Comment Set A California Department of Transportation, District 9

File: 09-Ker-202
MND
SCH: #2014111032

Southern California Edison (SCE) Banducci Substation – Mitigated Negative Declaration (MND)

Enclosure

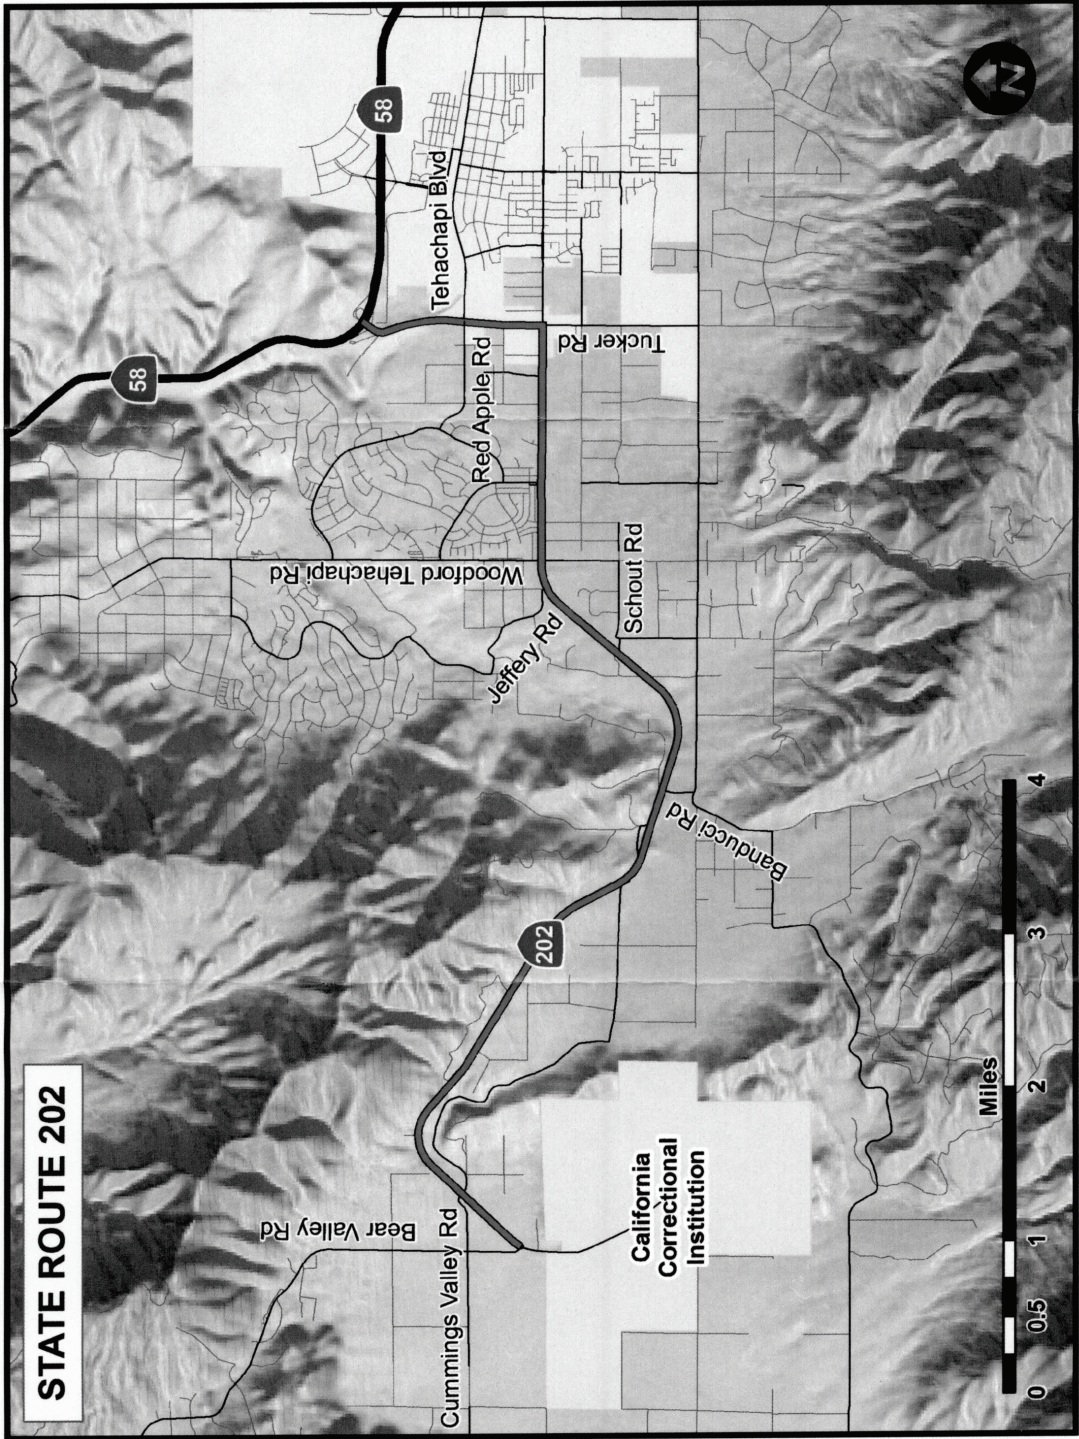
- State Route (SR) 202 was re-routed in the early 2000's and is incorrectly shown on many MND maps. (A "West Tehachapi Boulevard" label is also incorrect.) All maps should be updated accordingly per the SR 202 map enclosure. **A-1**
